# Railyards Specific Plan Update, KP Medical Center, MLS Stadium, & Stormwater Outfall

Final Subsequent Environmental Impact Report

P15-040 | SCH No. 2006032058

October 2016

**Figure 4.10-4**

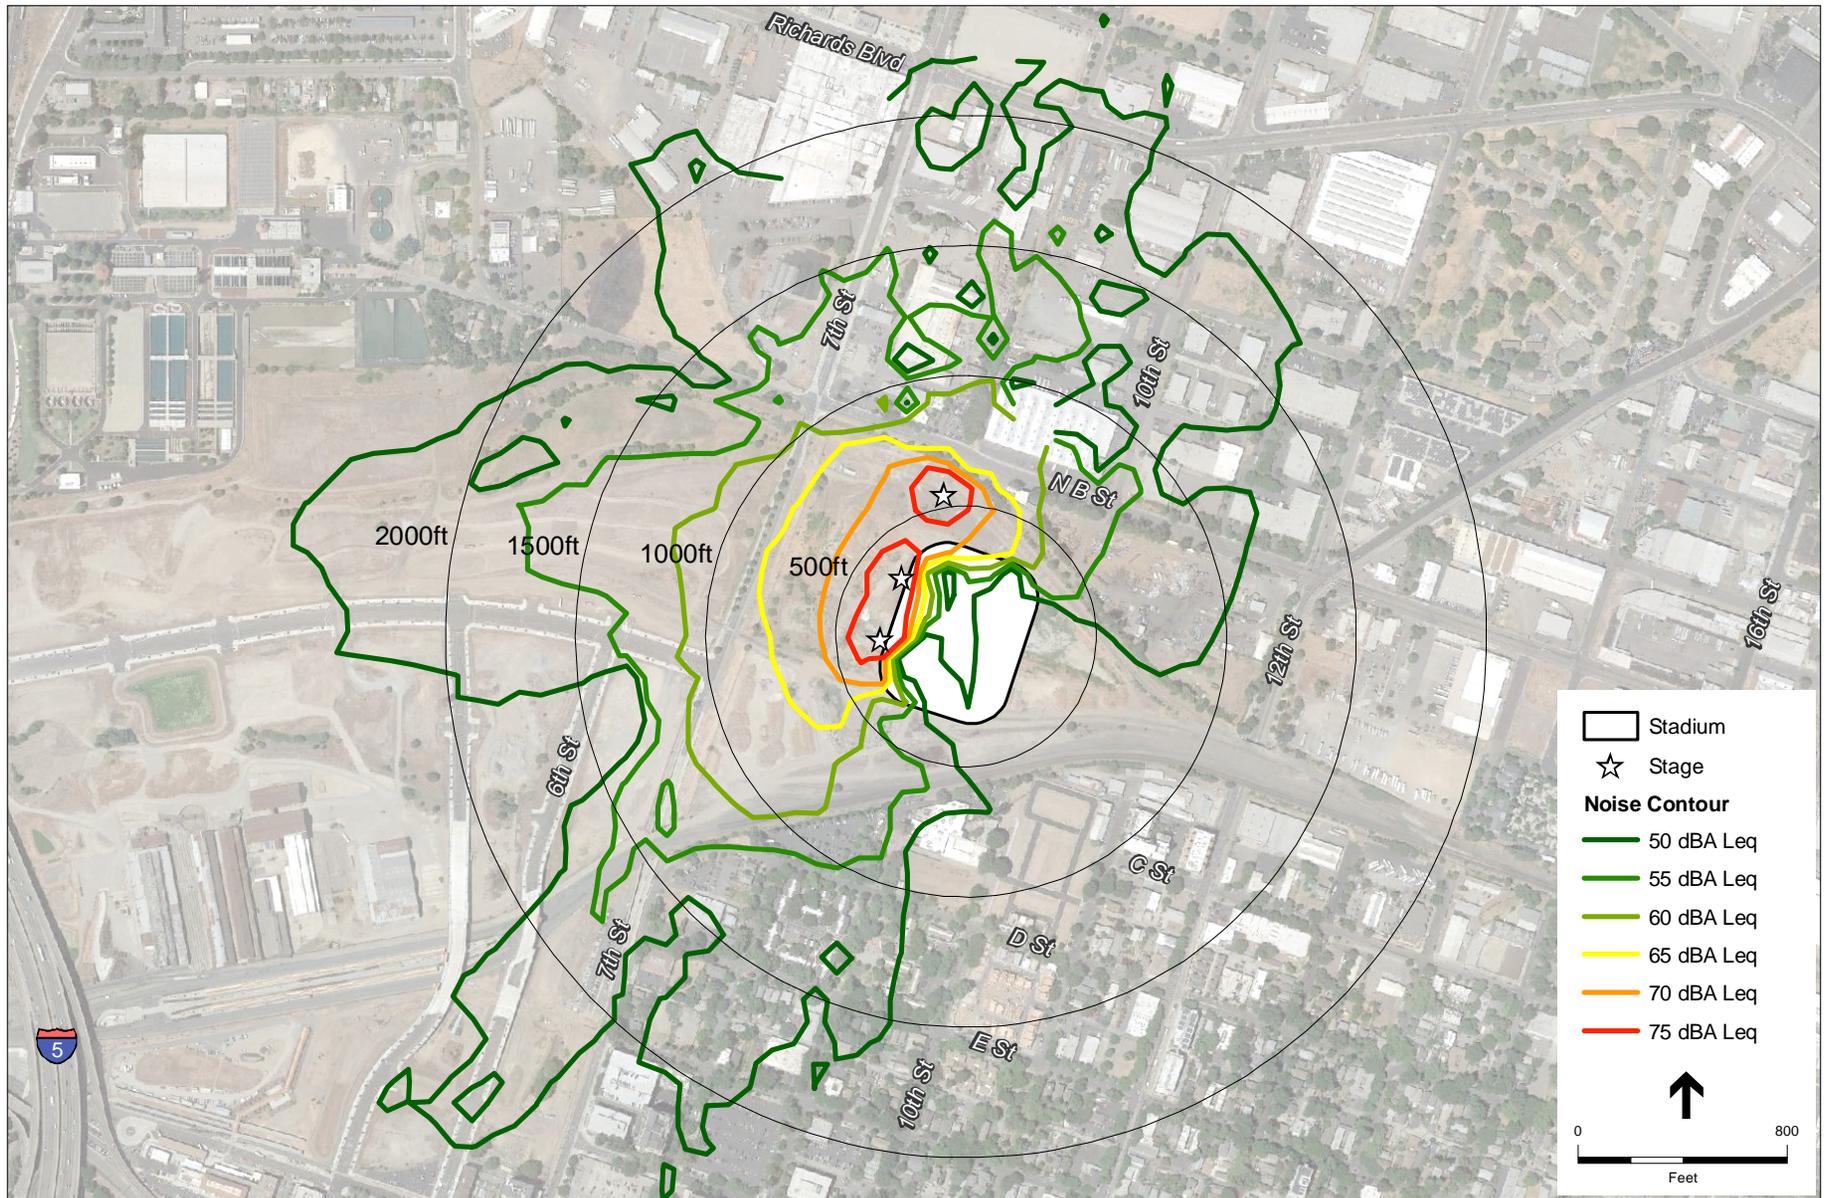
Figure 4.10-4, MLS Stadium - Soccer Game - Noise Contour Map - With Development, is added to demonstrate noise contours that would result from a soccer match at the MLS Stadium, while

**Figure 4.10-6**

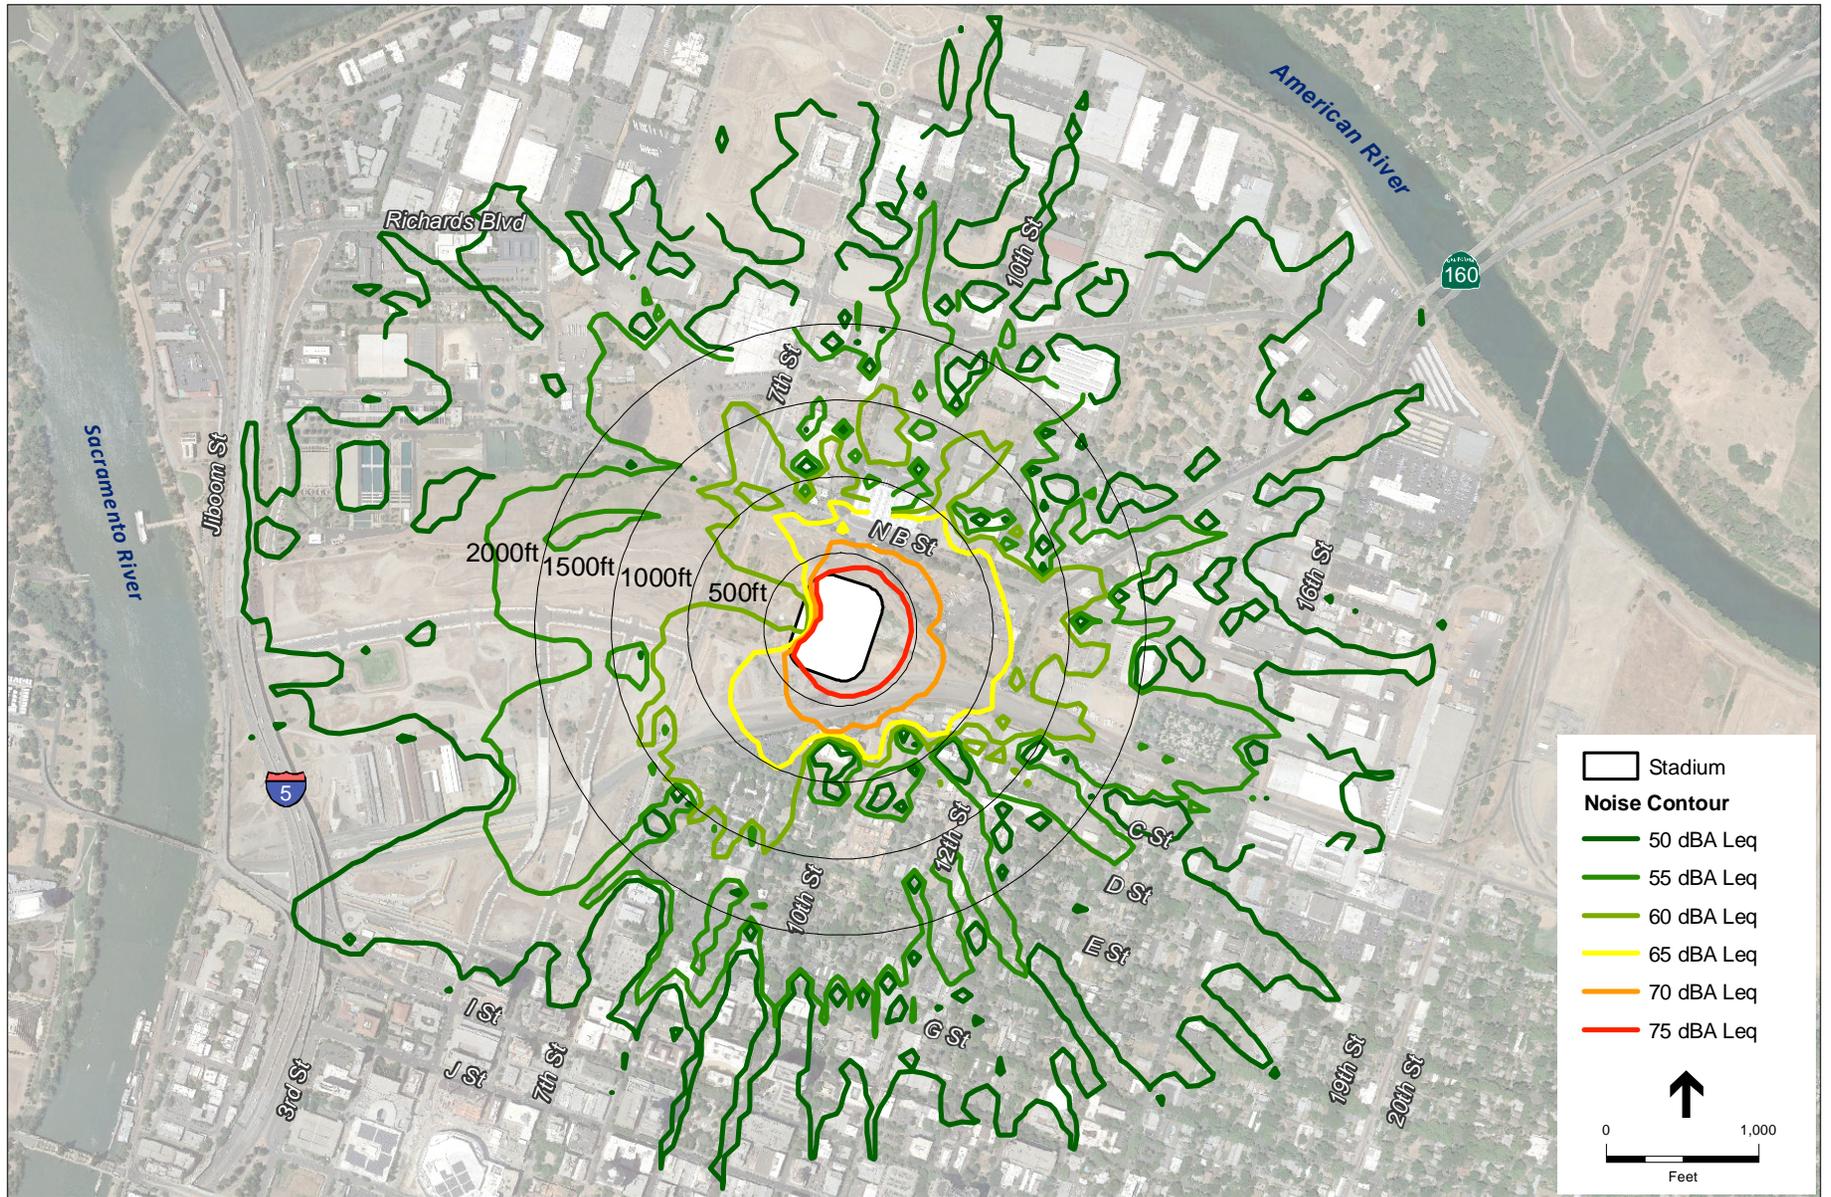
Figure 4.10-6, MLS Stadium - Music Concert - Noise Contour Map - With Development, is added to demonstrate noise contours that would result from a concert event at the MLS Stadium, while assuming development on parcels immediately surrounding the MLS Stadium within the RSP Area.

**Figure 4.10-7**

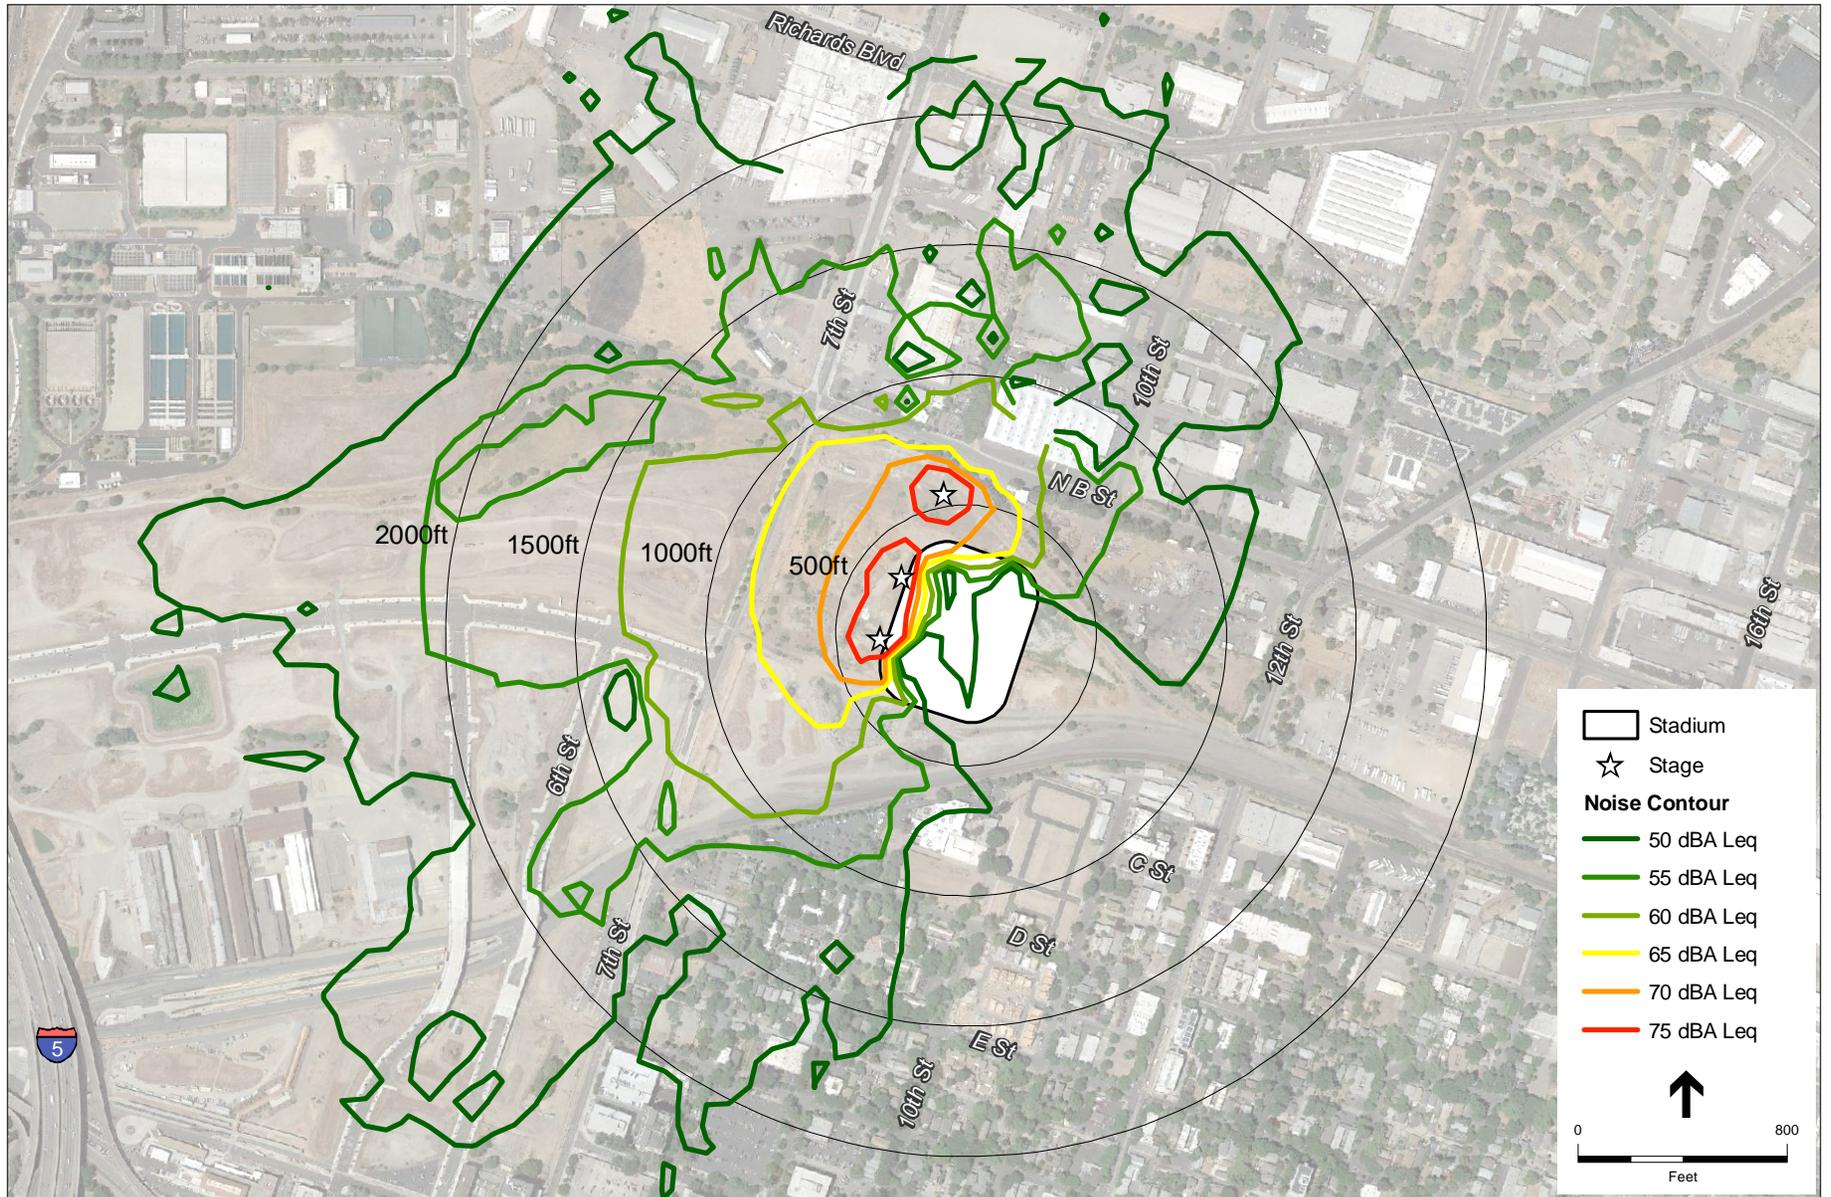
Figure 4.10-7, MLS Stadium - Soccer Game - Noise Contour Map - Zero Development, is added to demonstrate noise contours on opening day that would result from a soccer match at the MLS Stadium, while assuming no development on parcels immediately surrounding the MLS Stadium within the RSP Area.

**Figure 4.10-9**

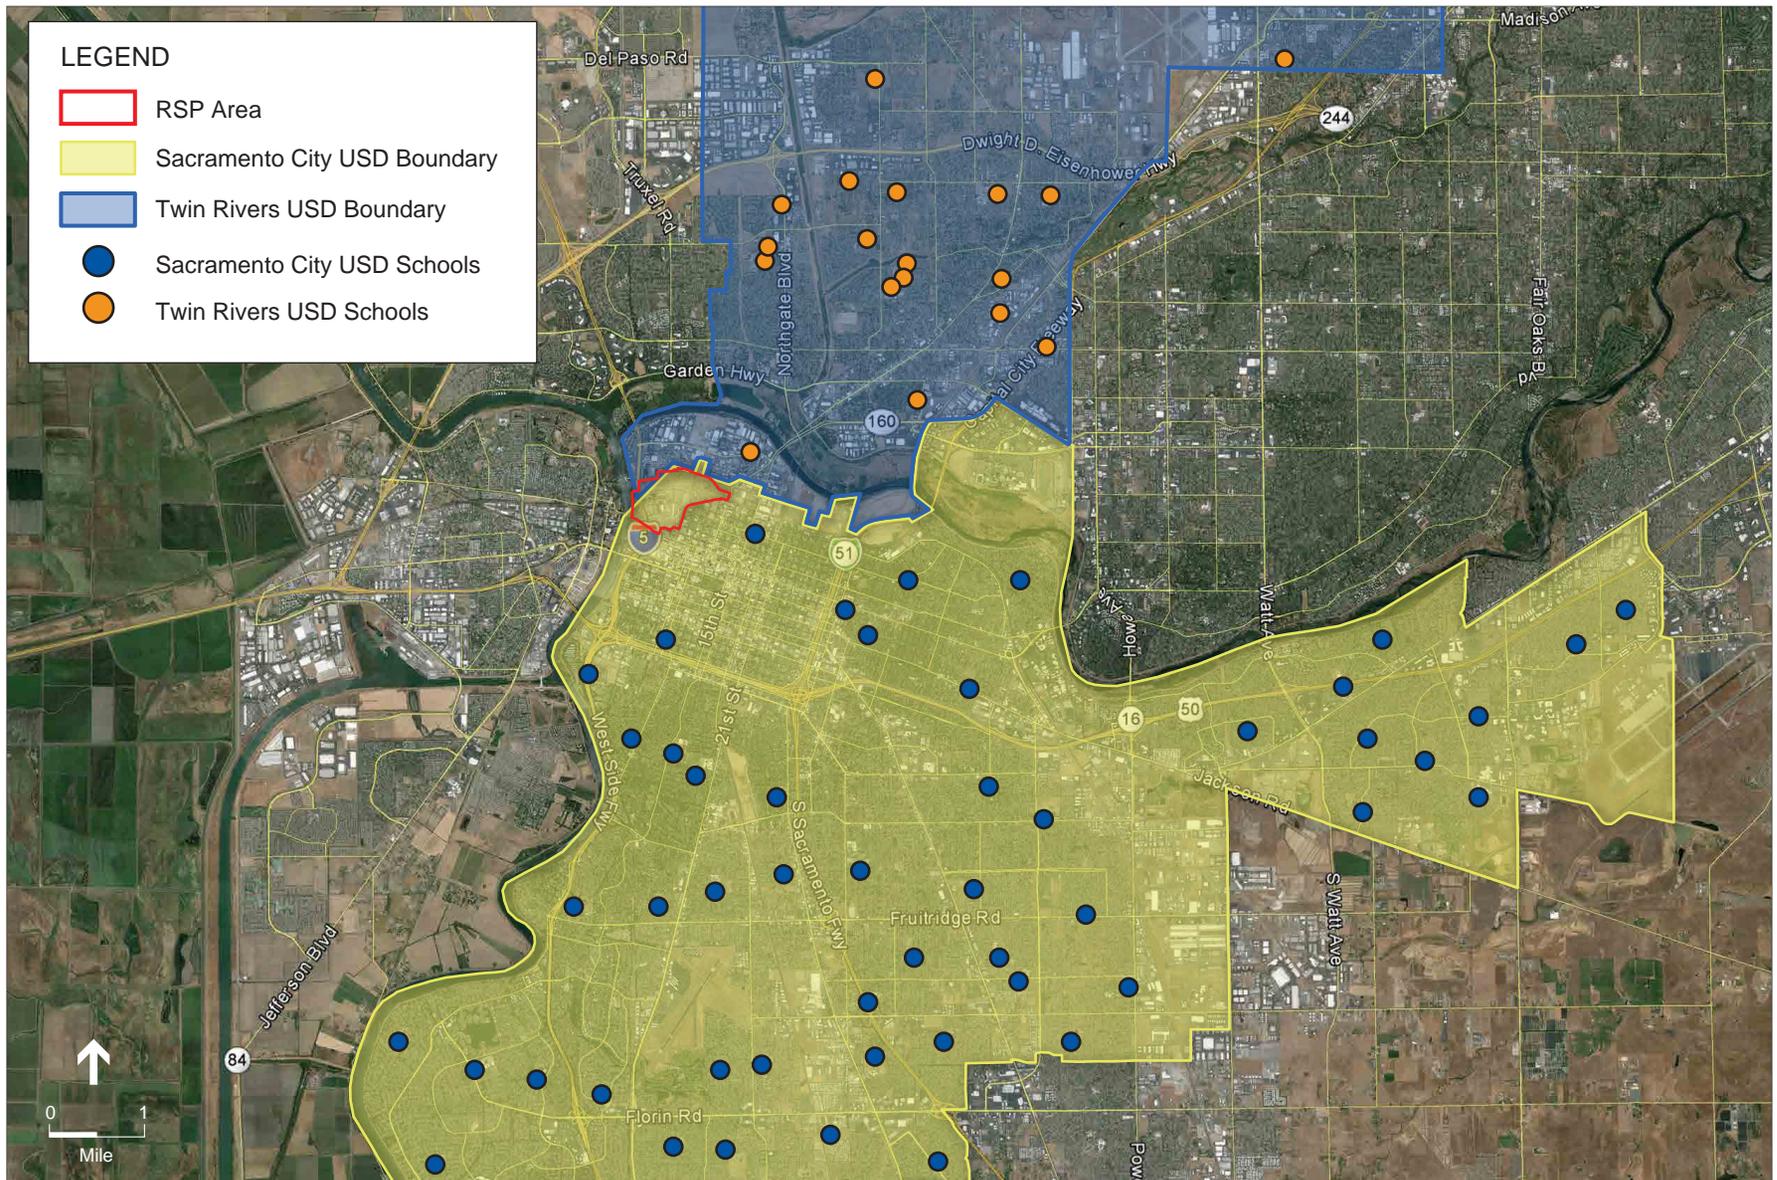
Figure 4.10-9, MLS Stadium - Music Concert - Noise Contour Map - Zero Development, is added to demonstrate noise contours on opening day that would result from a concert event at the MLS Stadium, while assuming no development on parcels immediately surrounding the MLS Stadium within the RSP Area.
